P-19992-2
E1191

JINDAL SYMBOL OF QUALITY AN ISO 9001 COMPANY	*JINDAL ALUMINIUM LTD.* *BANGALORE-560073 (INDIA)*		NAME	DATE
		DRAWN	J.P.KAUSHIK	23-10-2019
		CHECKED		
		APPROVED	*B.NATARAJA*	24-10-2019
1. ALL DIMENSIONS ARE IN mm. 2. ROUND OFF ALL SHARP CORNERS WITH 0.40 mm. 3. TOLERANCES WILL BE AS PER IS:3965-1981 , UNLESS OTHERWISE SPECIFIED		SCALE		1:1
		AREA mm^2		5930.788
		PERIMETER mm.		2523.041
		WEIGHT kg/m		16.013
PARTY'S NAME	SFO TECHNOLOGIES PVT. LTD., COCHIN	DRAWING No.		SECTION No.
PARTY'S DRAWING No.	N763521-C2D1 REV. 0.9	P-19992-2		-
ALLOY & TEMPER	6063 T6	E1191		E1191(ISSUE-2)
DESCRIPTION	HEAT SINK SECTION

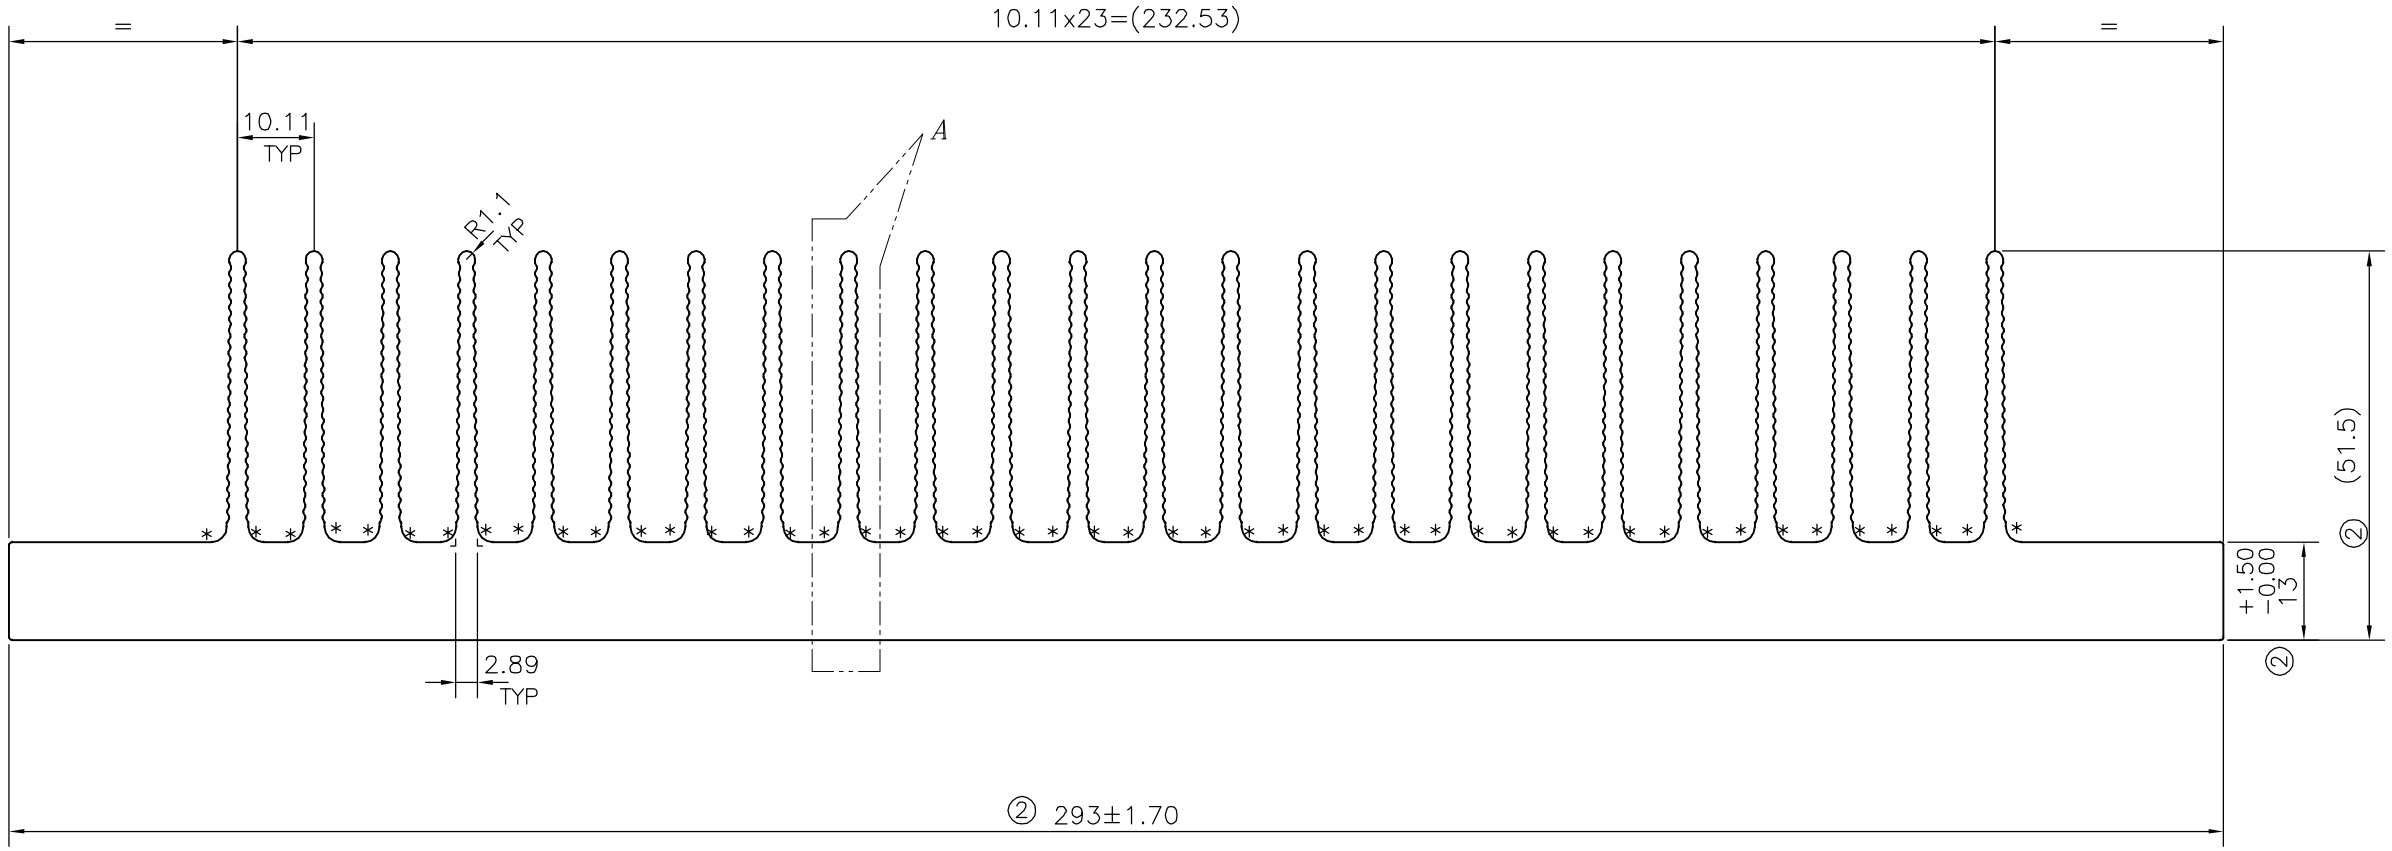
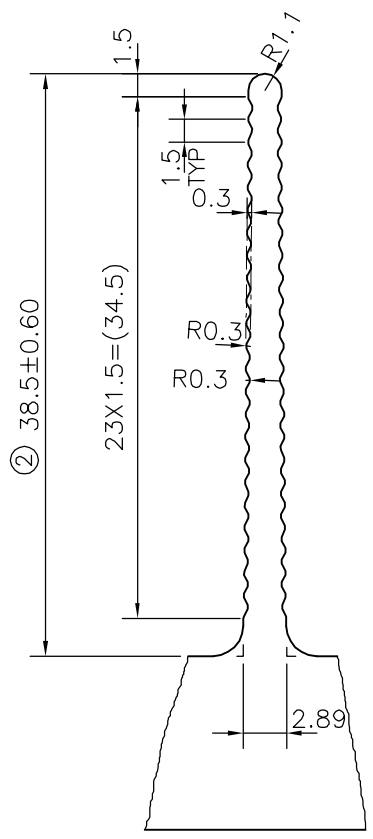
ISSUE-2

DIMENSION CHANGED FROM 11.5mm TO 13.0 mm,50 TO 51.5 & 292 TO 293 mm

WEIGHT ALSO CHANGED FROM 14.795 TO 16.013 kg/m
